PRODUCT CHANGE NOTIFICATION (PCN)

A-MCUP-80010/G MODULAR CABLE

CHANGE NOTIFICATION: PCN 20220425_A-MCUP-80010/G

DESCRIPTION OF CHANGES: CHANGE OF DATA SHEET
CHANGE OF DATA SHEET
New Draw.-No. ASS_7407_CArev04

ASSMANN WSW P/N	Drawing Number		ASSMANN WSW P/N	Drawing Number
A-MCUP-80010/G	ASS_7407_CArev03	↔	A-MCUP-80010/G	ASS_7407_CArev04

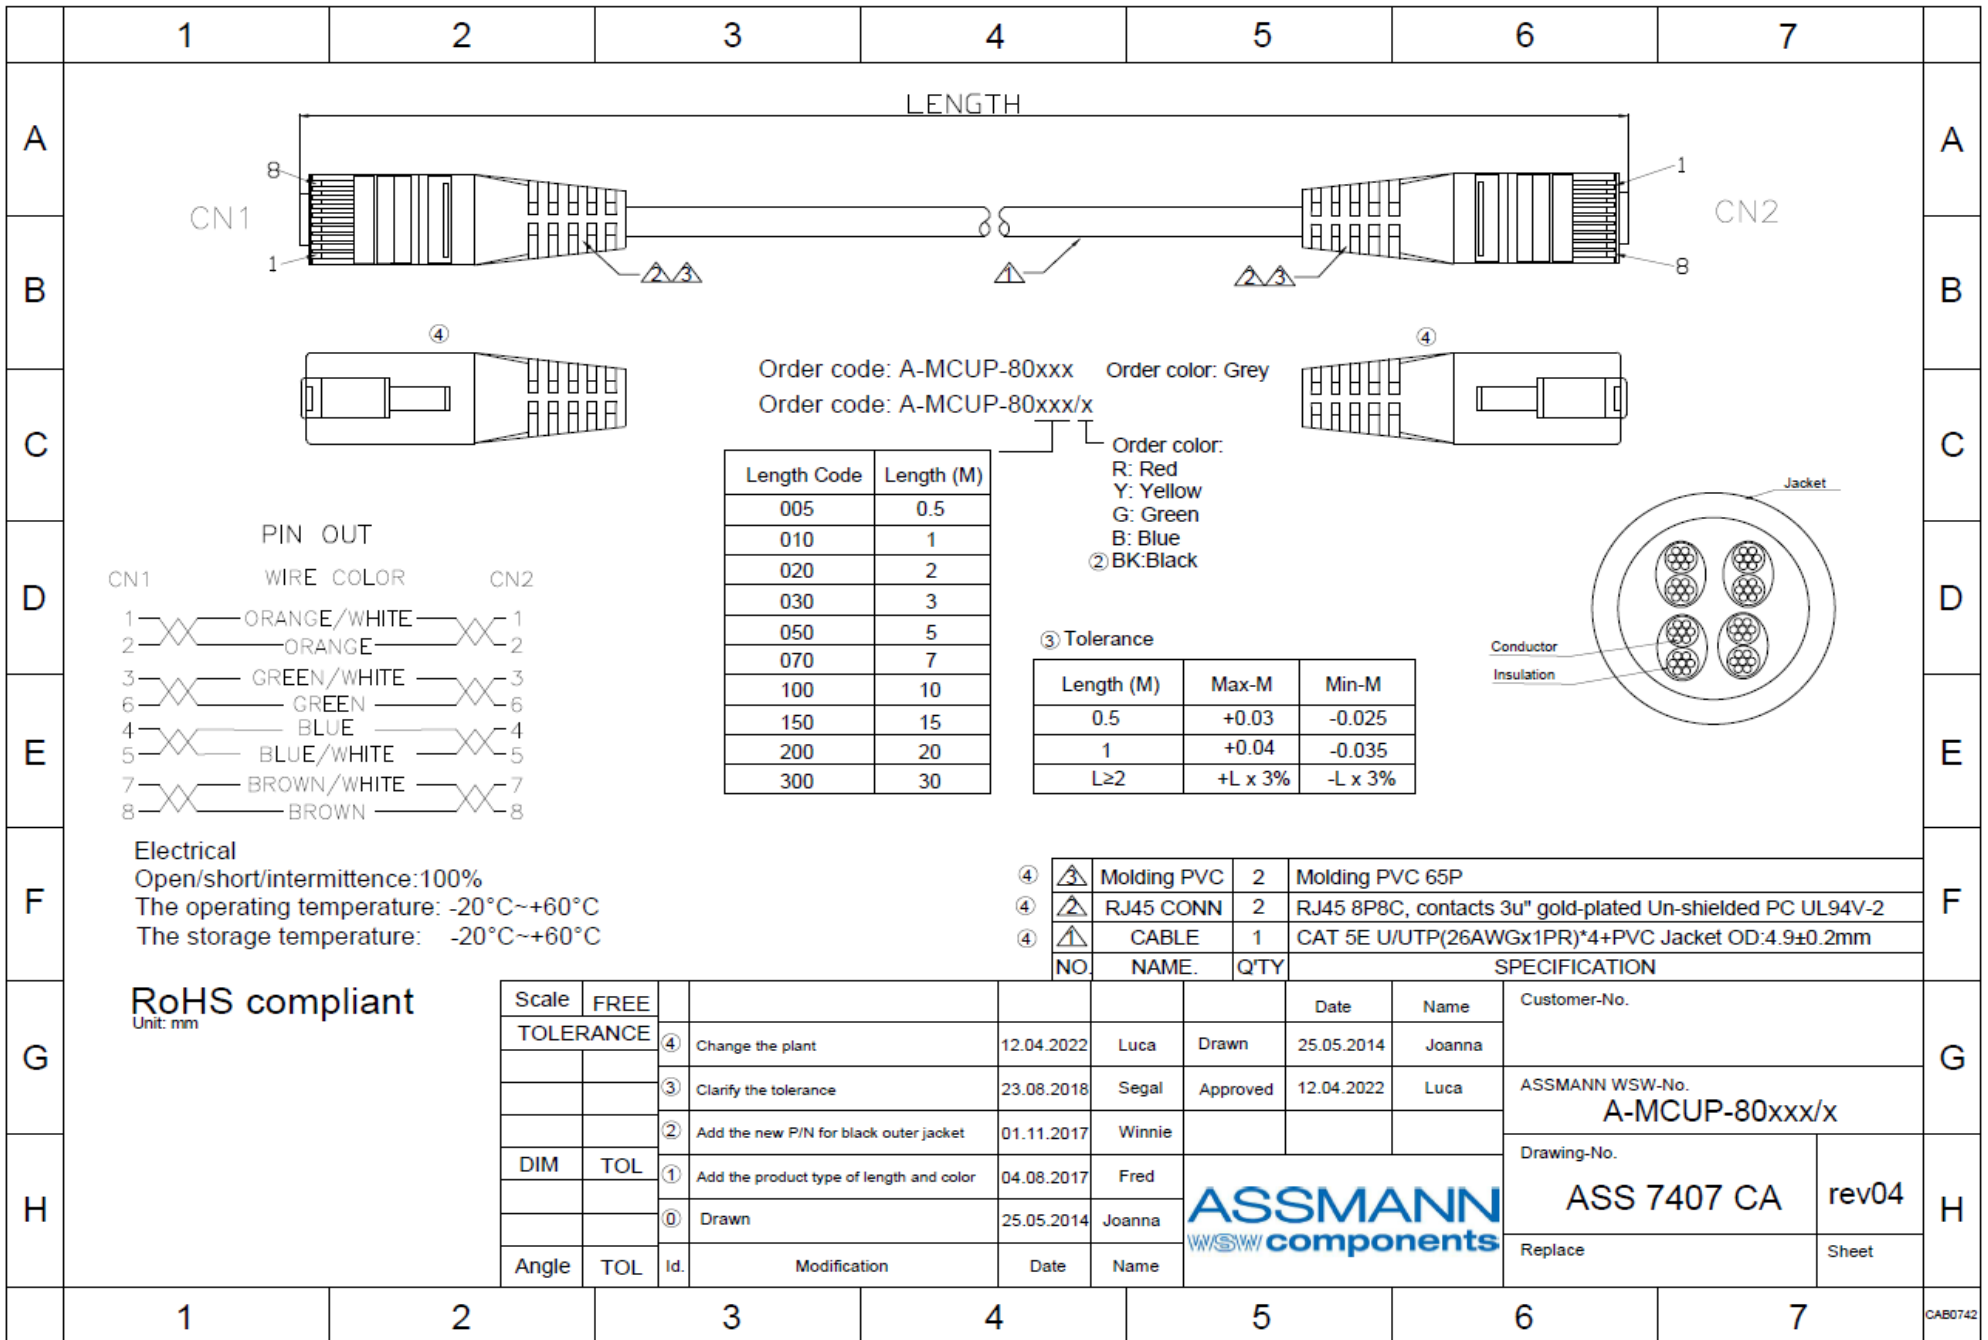
REASON FOR CHANGE: CHANGE OF PRODUCT LOCATION
CHANGE OF PRODUCT LOCATION

A-MCUP-80010/G	OLD VERSION	A-MCUP-80010/G	NEW VERSION																																
<p>Appearance</p>		<p>Appearance</p>																																	
<p>BOM</p> <table border="1"> <thead> <tr> <th>NO.</th> <th>NAME.</th> <th>QTY</th> <th>SPECIFICATION</th> </tr> </thead> <tbody> <tr> <td>③</td> <td>Molding PVC</td> <td>2</td> <td>Molding PVC 45P</td> </tr> <tr> <td>②</td> <td>RJ45 CONN</td> <td>2</td> <td>RJ45 8P8C, Two Fork gold plated contacts 3u" gold</td> </tr> <tr> <td>①</td> <td>CABLE</td> <td>1</td> <td>UTP(26AWG*x1PR)*4+PVC OD:4.9±0.2mm</td> </tr> </tbody> </table>		NO.	NAME.	QTY	SPECIFICATION	③	Molding PVC	2	Molding PVC 45P	②	RJ45 CONN	2	RJ45 8P8C, Two Fork gold plated contacts 3u" gold	①	CABLE	1	UTP(26AWG*x1PR)*4+PVC OD:4.9±0.2mm	<p>BOM</p> <table border="1"> <thead> <tr> <th>NO.</th> <th>NAME.</th> <th>QTY</th> <th>SPECIFICATION</th> </tr> </thead> <tbody> <tr> <td>④</td> <td>Molding PVC</td> <td>2</td> <td>Molding PVC 65P</td> </tr> <tr> <td>④</td> <td>RJ45 CONN</td> <td>2</td> <td>RJ45 8P8C, contacts 3u" gold-plated Un-shielded PC UL94V-2</td> </tr> <tr> <td>④</td> <td>CABLE</td> <td>1</td> <td>CAT 5E U/UTP(26AWGx1PR)*4+PVC Jacket OD:4.9±0.2mm</td> </tr> </tbody> </table>		NO.	NAME.	QTY	SPECIFICATION	④	Molding PVC	2	Molding PVC 65P	④	RJ45 CONN	2	RJ45 8P8C, contacts 3u" gold-plated Un-shielded PC UL94V-2	④	CABLE	1	CAT 5E U/UTP(26AWGx1PR)*4+PVC Jacket OD:4.9±0.2mm

NO.	NAME.	QTY	SPECIFICATION																																
③	Molding PVC	2	Molding PVC 45P																																
②	RJ45 CONN	2	RJ45 8P8C, Two Fork gold plated contacts 3u" gold																																
①	CABLE	1	UTP(26AWG*x1PR)*4+PVC OD:4.9±0.2mm																																
NO.	NAME.	QTY	SPECIFICATION																																
④	Molding PVC	2	Molding PVC 65P																																
④	RJ45 CONN	2	RJ45 8P8C, contacts 3u" gold-plated Un-shielded PC UL94V-2																																
④	CABLE	1	CAT 5E U/UTP(26AWGx1PR)*4+PVC Jacket OD:4.9±0.2mm																																
<p>FOR DETAIL, PLEASE TAKE ATTACHED NEW DRAWING: FOR REFERENCE</p>
